TECHNICAL INFORMATION

Early SLABS ECU Replacement

No: 70/01/99/NAS
Ref:
Issue: 1
Date: 06/04/99

DISCOVERY Series II (LT)

Figure 1

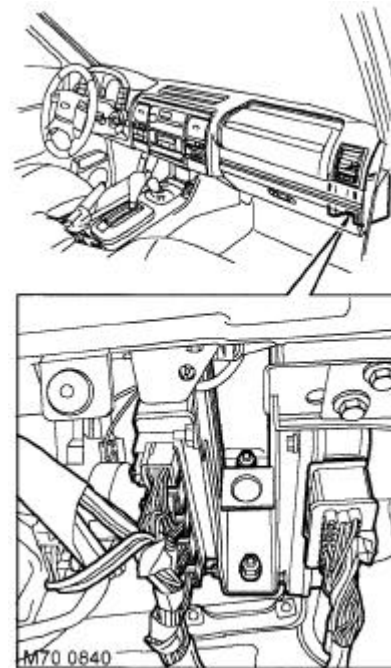
1. Open the glovebox and grasp the hinge stop mechanisms on both sides of the box.
2. Compress the hinge stop springs completely so that the roller on the end of the stop mechanism can be moved through the slot in the fascia opening.
3. Drop the glovebox down and inspect the black SLABS ECU for a yellow dot. (Figure 1)
4. If the yellow dot is present, connect TestBook and choose the following menus:
 - Discovery Series II SLABS
 - Vehicle Maintenance icon.
 - SLABS ECU Replacement icon
